# Master Builders Queensland

**RD 2004-02 – Energy Efficiency for houses**

**RIS 2005-02 - Regulation Impact Statement**

**Organisation:** Master Builders Queensland

### Option 1.

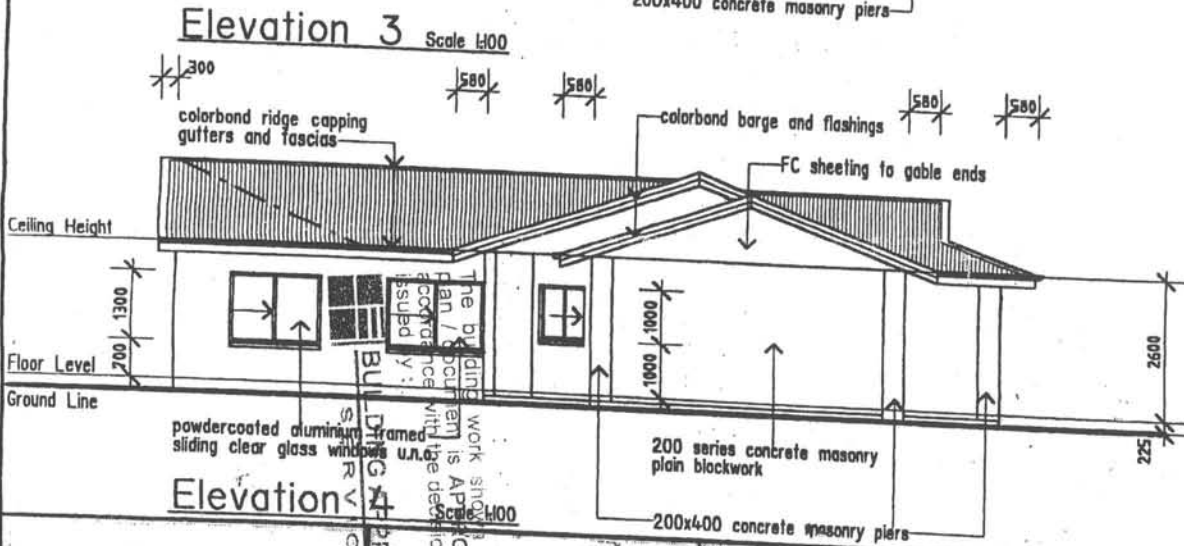
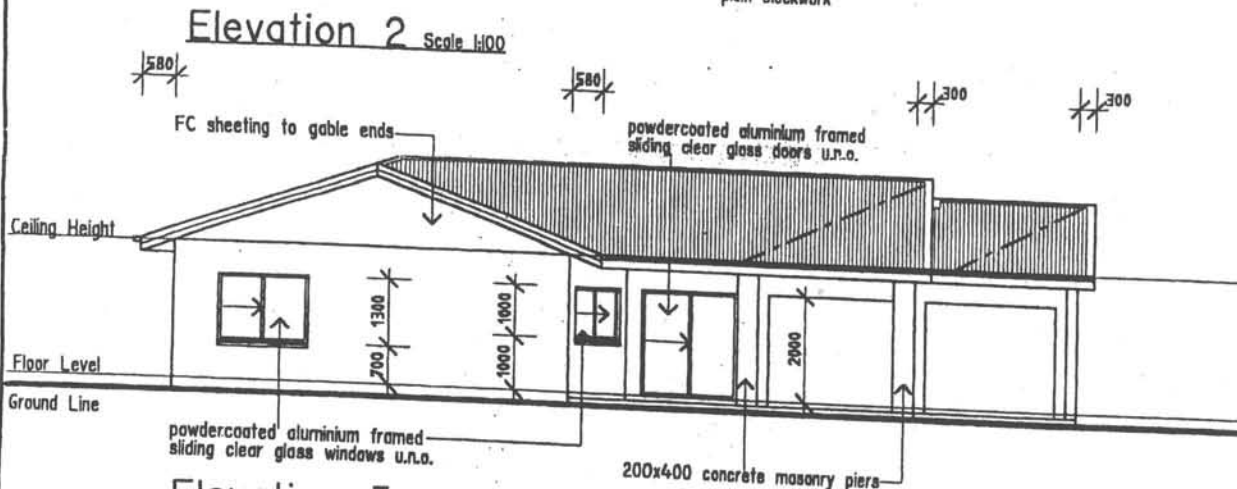
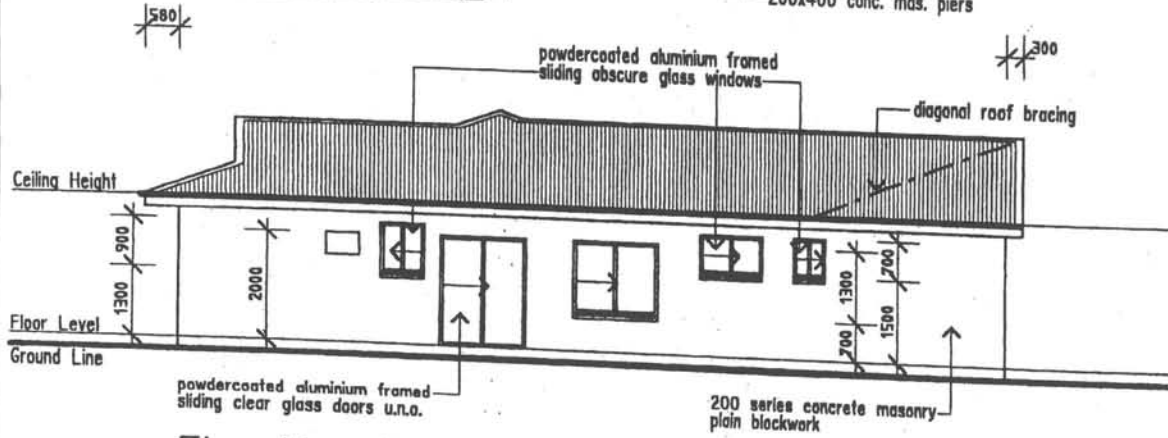
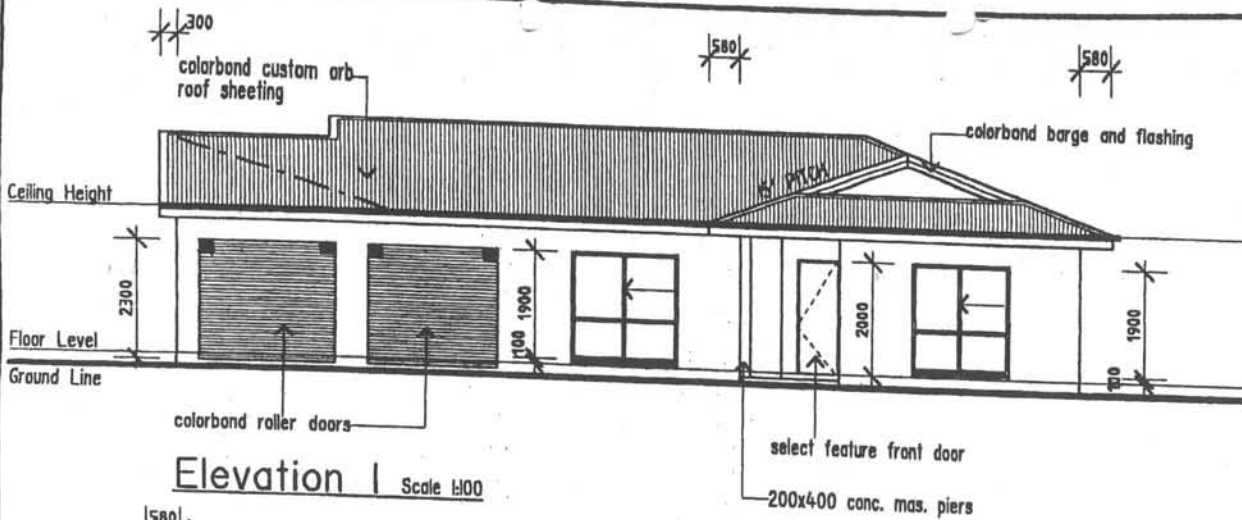
**Option 1.** Change internal walls to plasterboard lining with battening with insulation to inside of external walls.

Internal partitions from block to plasterboard on steel frame.	\$353.00
Replace steel framed doors to timber frame with architraves.	\$616.00
Line internal of external wall with plasterboard and timber sills and skirting.	\$4,024.00
<u>Sub Total</u>	<u>\$4,993.00</u>
Steel batten off the internal face of the external wall and insulate With fibreglass insulation. Extra width sills included.	\$3,820.00
Increase thickness of ceiling insulation	\$48.00
Cost of upgrading glazing. Requires one hood to Bedroom 3.	\$498.00
<b><u>Total of this option is</u></b>	<b><u>\$9,359.00</u></b>

- For. Retains the strength of block and is the least expensive increase in price when the cyclone category increases from C1. Materials sourced locally. Trades sourced locally. No termite risk. High impact resistance.
- Against. Loss of 3.2M2 of living area floor space. Is an increase of \$73 per M2 of living area or an increase of 7.25% of the contract price.

TITLE: Proposed Residence at  
Lot 75 Timberlea Drive  
Edmonton.

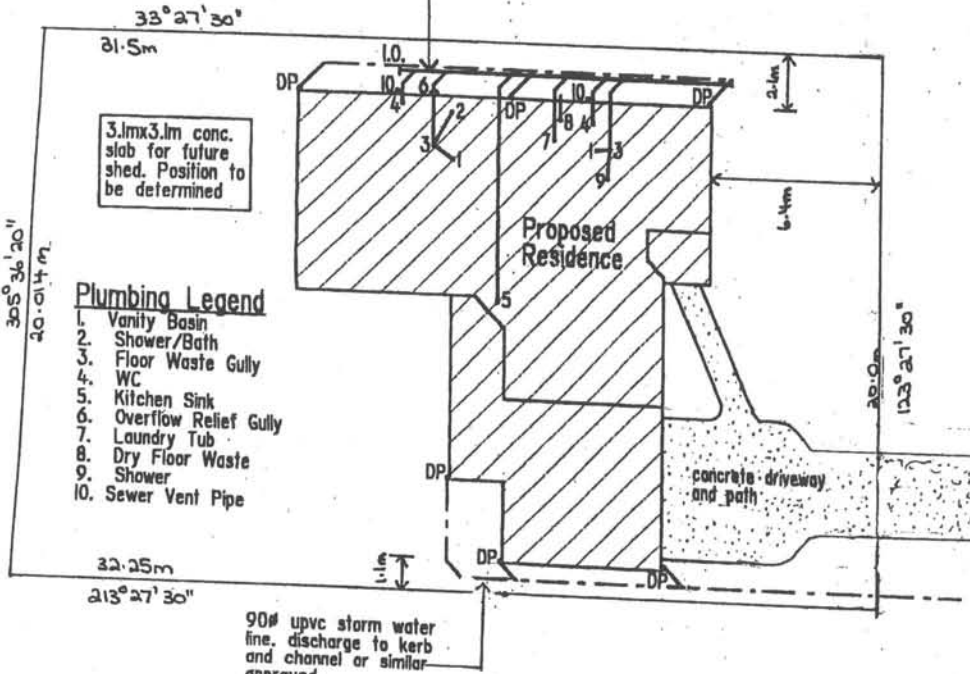
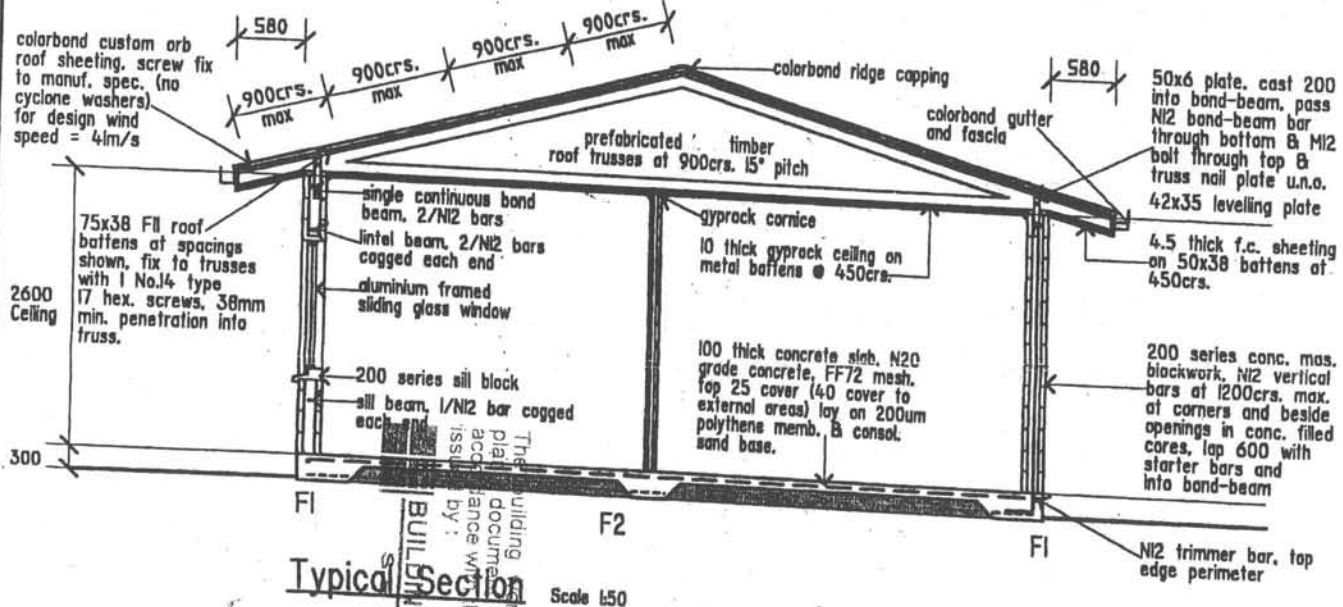
During a recent visit to Cairns with Building Codes Queensland, a new home complying to the current Queensland Deemed-to-Satisfy requirements was viewed and the cost to upgrade the house to the proposed Deemed-to-Satisfy presented. The upgrade involved insulating the external wall to R1.4 and shading one window.

The original contract price on this 128m<sup>2</sup> home (entry level first home market) was \$129,049. The increase in cost to comply with the proposed Deemed-to-Satisfy was \$9,359 which represents a 7.25% increase in the contract price. It also resulted in a loss of 3.2m<sup>2</sup> of living area floor space. The house plans and costings are included at Attachment A.
